## Justification for LEU Conversion Related TS Amendments

**TECHNICAL SPECIFICATIONS  
FOR THE  
UNIVERSITY OF VIRGINIA REACTOR**

FACILITY LICENSE No. R-66  
DOCKET No. 50-62

December 10, 1992

Figure 2.1 Safety Limits with Forced Convection Flow

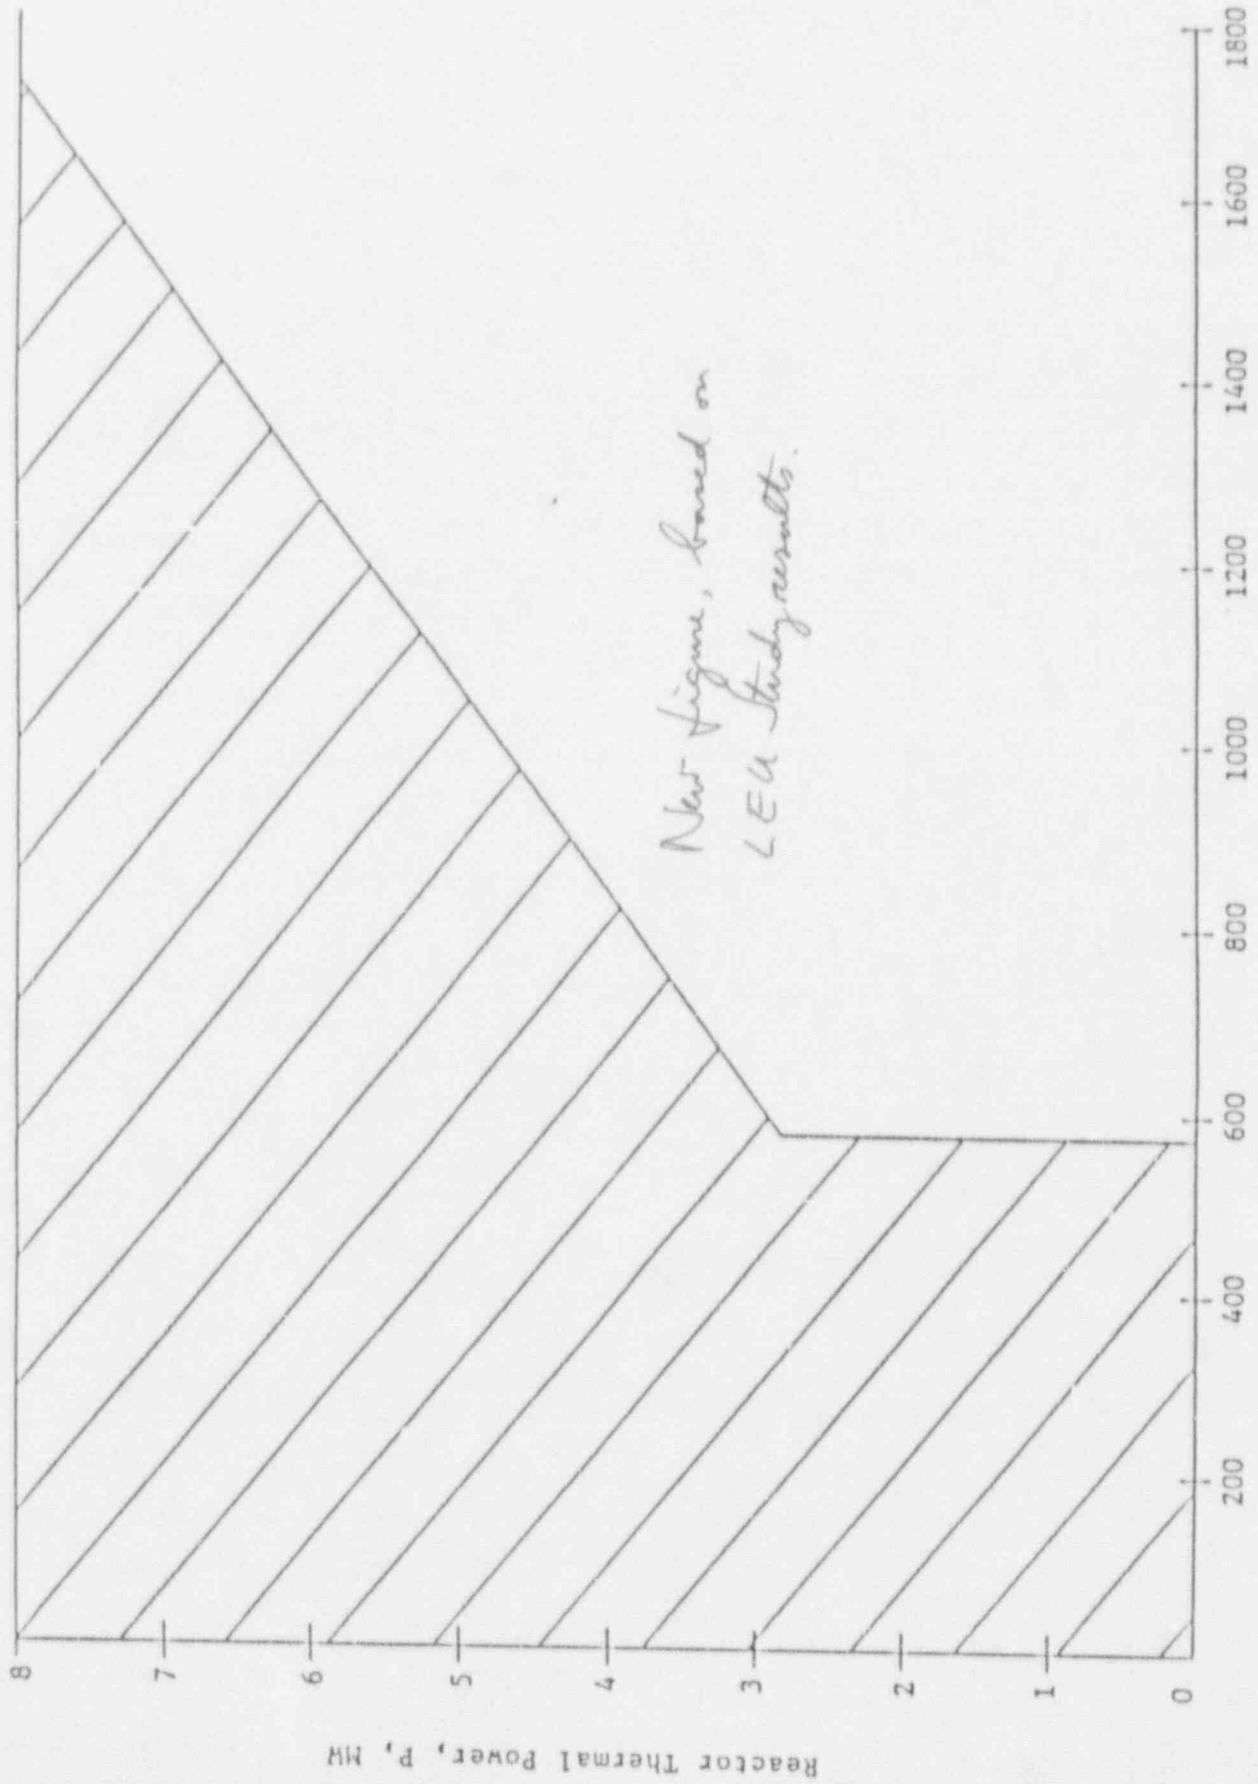
- (1) The pool water level shall not be less than 19 ft above the top of the core.
- (2) The reactor coolant inlet temperature shall not be greater than 111°F.
- (3) The true value of reactor coolant flow shall not be below 575 gpm.
- (4) The combination of true values of reactor core power and reactor coolant flow shall be below the line defined by:

$$P = 0.24 + (4.5 \times 10^{-3} * W)$$

$$P = 0 \text{ for } W < 575; P \text{ in MW, } W \text{ in gpm}$$

The allowed region of operation is shown by the unshaded region of Figure 2.1.

*These changes  
are Based on  
LEU Study  
results.*

Basis: Above 575 gpm in the region of full power operation, the criterion used to establish the safety limit was a burnout ratio of 1.49 including the worst variation in the manufacturer's tolerance and specification, hot channel factors and other appropriate uncertainties. The analysis is given in the LEU SAR.

Below 575 gpm buoyancy forces competing with forced convection may lead to flow instabilities in some of the channels and is therefore not allowed. The analysis of the loss of flow transient shows that during the transition from forced convection to natural convection following a loss of flow and reactor scram that the fuel temperature is well below the temperature at which fuel clad damage could occur.
